Responses to Comments

Low Carbon Fuel Standard Regulation

Released September 21, 2015

September 24, 2015 Board Hearing

Figure 8. Change in Arable Land Plus Permanent Crops: 2004–2006 to 2010–2012

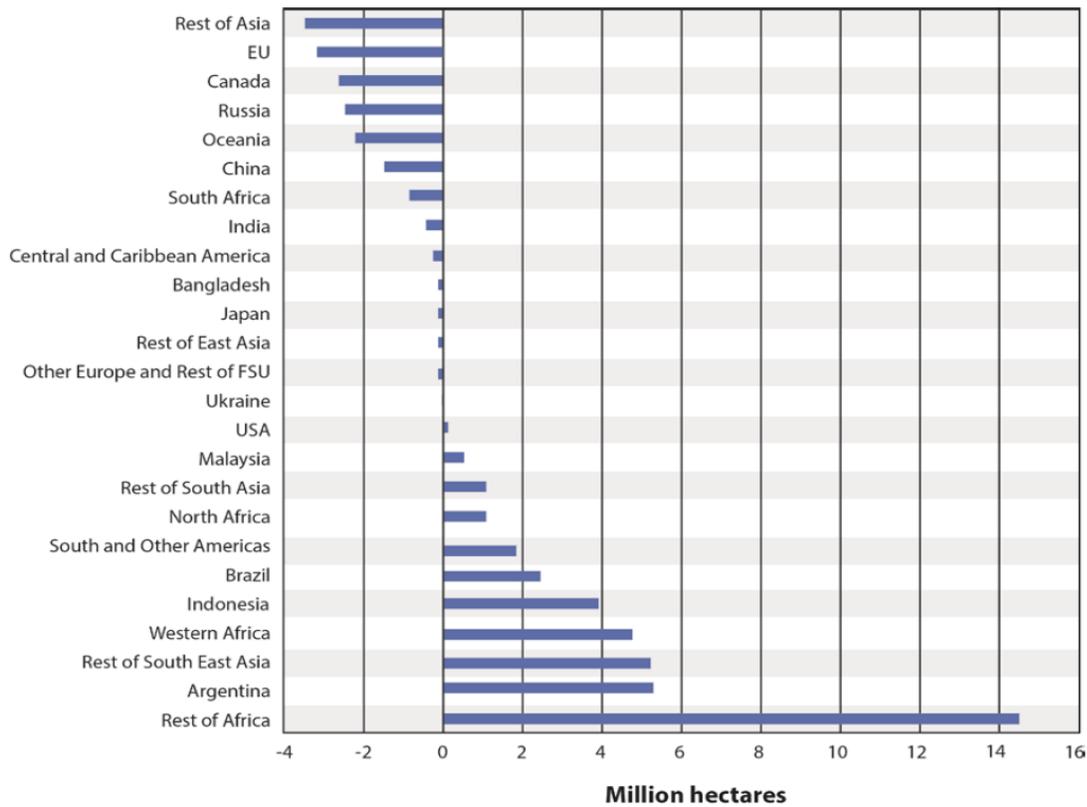
The countries in Figure 8 that either had negligible or negative extensive land use changes **should be presumed to not have converted pasture or forest to crops in response to biofuel-induced higher prices.** Rather, the presumption should be that **any predicted change in land used in agriculture came from cropland that did not go out of production.**⁷

Figure 8 from Babcock & Iqbal is embedded below. Note that many countries and regions for which CARB's latest GTAP analysis predicts extensive change from forest and grassland to crops actually showed cropland losses or no change. This includes Canada, EU, Japan, China, India, Russia, the U.S., and Oceania. Further, the amount of corn ethanol-induced conversion of

forest and grassland in the U.S. predicted by CARB's GTAP model is two to four times larger than the actual extensive land use change in the U.S. driven by *all factors in aggregate*.
